**Amendments to the Drawings:**

## REMARKS

FIG. 17

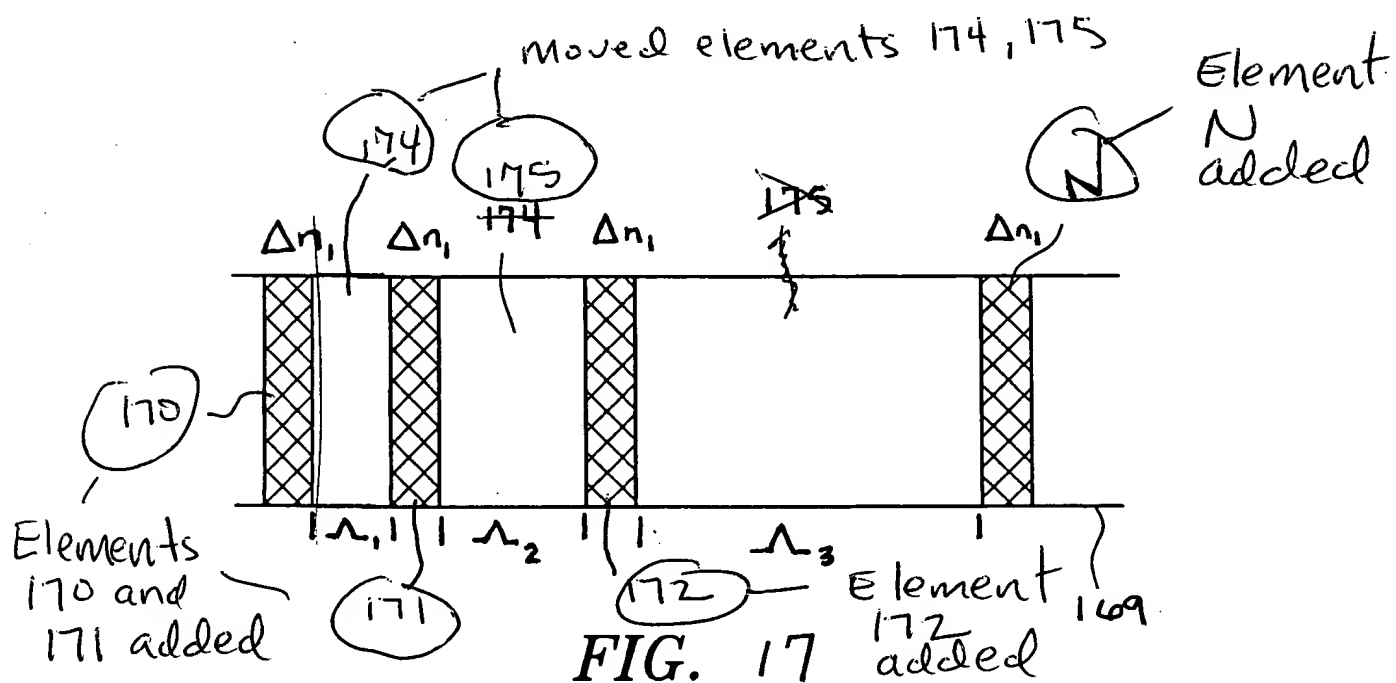
In Fig. 17, the reference numbers 170, 171, and 172 have been added as requested. Further, reference numbers 174 and 175 were moved as reflected in the Annotated Sheet Showing Changes to match their respective positions in original Fig. 17. Further, N was added to the last stripe as reflected in original Fig. 17 and described in the replacement paragraph inserted at page 15, line 14. (See Amendment filed April 15, 2004.)

First, Fig. 17 was objected for not including reference numbers 170-172 referenced in the amended specification dated April 15, 2004. The noted reference numbers have now been included in the replacement drawing sheet including amended Fig. 17. Accordingly, the objection to Fig. 17 is now moot.
